UNITED STATES
NUCLEAR REGULATORY COMMISSION
WASHINGTON, D.C. 20555-0001

SAFETY EVALUATION REPORT

Docket No. 72-8
Calvert Cliffs
Independent Spent Fuel Storage Installation
Renewed Materials License No. SNM-2505
Amendment No. 11

Figure 6-2 - TN results (NUH32PHB-0408) compared to staff's confirmatory calculations (COBRA-SFS model) for 32PHB DSC /TC in vacuum drying (N2 blowdown, 29.6 kW)

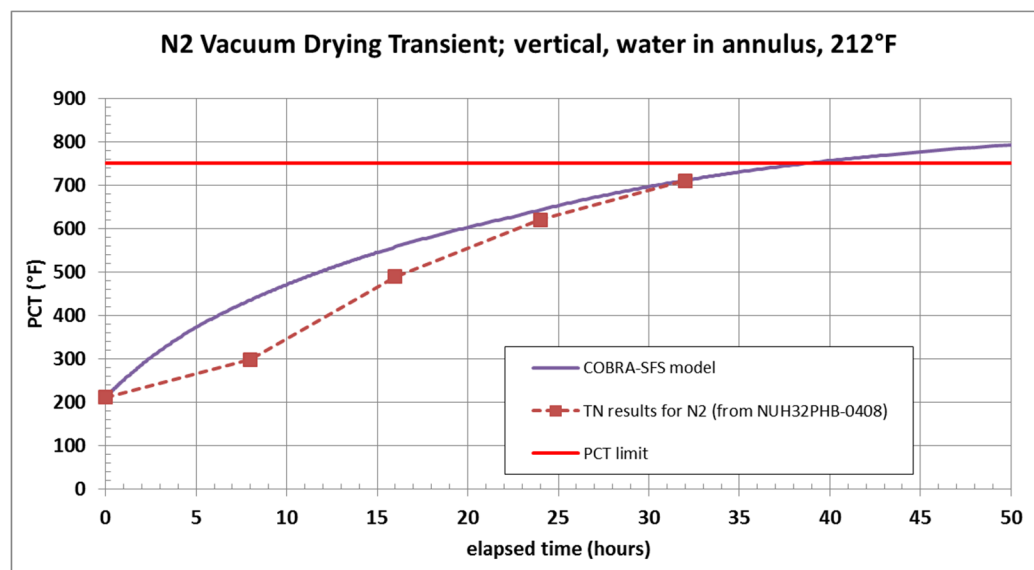
The staff reviewed TN Calculation NUH32PHB-0408 and performed the confirmatory thermal analyses for 32PHB DSC vacuum drying using nitrogen and helium, respectively, for blowdown. The comparisons are listed in Tables 6-1 and 6-2 and Figures 6-2 and 6-3 of this SER. The staff noted from Table 6-1 and Figure 6-2 of this SER that at 32 hours when using nitrogen for blowdown, the PCT of 711.5°F from the staff's confirmatory calculation is consistent with the PCT of 711°F from the licensee's model. For the post-vacuum drying steady-state after backfilling with helium (DSC/TC in vertical orientation and water at 212°F in TC/DSC annulus), the licensee assumed perfect contact in all locations and calculated a steady-state fuel cladding temperature of 592°F which is lower than the fuel cladding temperature of 604°F from the staff's confirmatory analysis (PNNL COBRA-SFS results). The staff also performed the confirmatory analysis by assuming a contact gap 0.01 inch in all locations where the aluminum basket plates are perpendicular to the steel basket plates, and calculated a steady-state fuel cladding temperature of 613°F. After reviewing the licensee's evaluation and performing the confirmatory analyses, the staff determined that the time limit of 32 hours for nitrogen blowdown is acceptable for 32PHB DSC, loaded with 29.6 kW, during vacuum drying.

Figure 6-3 - TN results (NUH32PHB-0408) compared to staff's confirmatory calculations

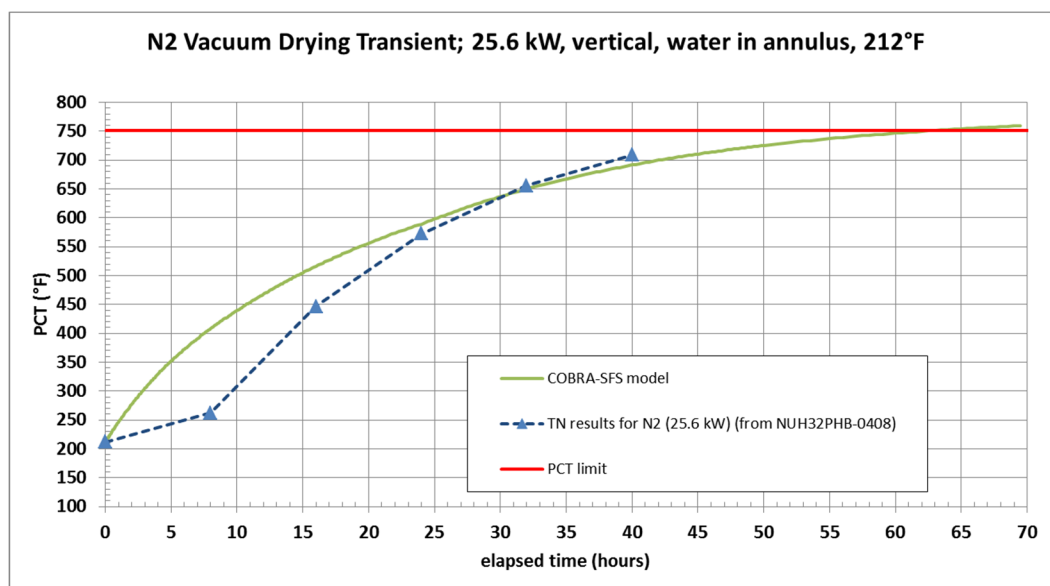
The staff also performed the confirmatory analyses for 32PHB DSC vacuum drying with nitrogen blowdown at the heat loads of 25.6 kW and 23.04 kW, respectively. The staff's confirmatory analyses calculated the PCTs of 692°F for 25.6 kW at 40 hours and 694°F for 23.04 kW at 56 hours, as shown in Table 6-2 below. The licensee's calculations (TN results) for vacuum drying (with N₂ blowdown and 25.6 kW), compared to the staff's confirmatory calculations with COBRA-SFS model is displayed in Figure 6-3 of this SER.

Compared to the PCTs of 709°F for 25.6 kW at 40 hours and 718°F for 23.04 kW at 56 hours from the licensee's calculations (NUH32PHB-0406), the staff concluded that the licensee's analyses are consistent with the staff's confirmatory analyses for heat loads of 25.6 kW and 23.04 kW, respectively. In addition, the staff also concludes that the heat loading configurations of 23.04~25.6 kW and ≤23.04 kW, as listed in TS 3.3.3.1, are acceptable when using nitrogen for blowdown operation. Therefore, the staff determined that the time limits proposed in TS 3.3.3.1 for the 32PHB DSC in the TC using N₂ blowdown in vacuum drying are acceptable.
